Technical *Info*

Installation of the drive belt kit CT 919K1/K3/K4/K5 for an Audi A4,1.8 20 V (refitting on the hydrospanner of vehicles built before 1998)

Fig. 2

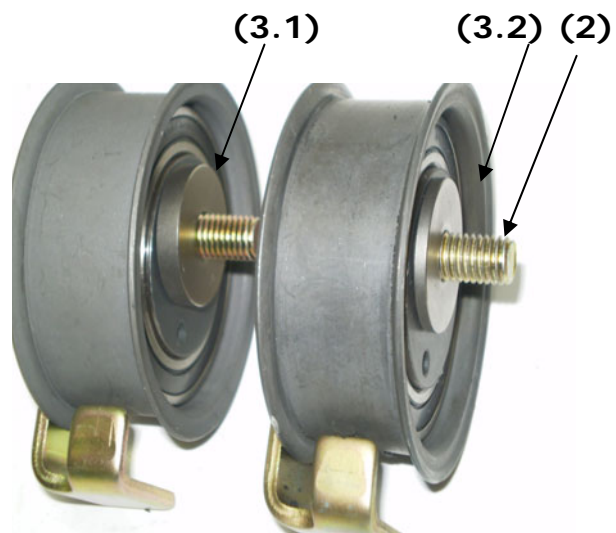
The belt drive makes noises after operating for a short time,

The newly installed tension roller is not the correct distance from the engine and allows the belt to rub at the side on the inner flanged wheel. (set back)

When refitting vehicles built before and during 1998, the old version stud bolt (1) must be removed. The new version is then screwed into the same hole with a pre-mounted spacer (2). The problem here is that the manufacturer has **two!!** Different thicknesses of spacer (3.1)+(3.2) which define the distance from the roller to the engine. Despite the Vehicle Identification No. delimitation (prod. month: 01/96) it is still not absolutely unequivocal which kit must be used since the stated Vehicle Identification No. can deviate from this. One should always check whether the replaced tension roller is mounted aligned in the belt drive. There will definitely be noises produced otherwise or even grave damage to the engine.

New tension roller engineering
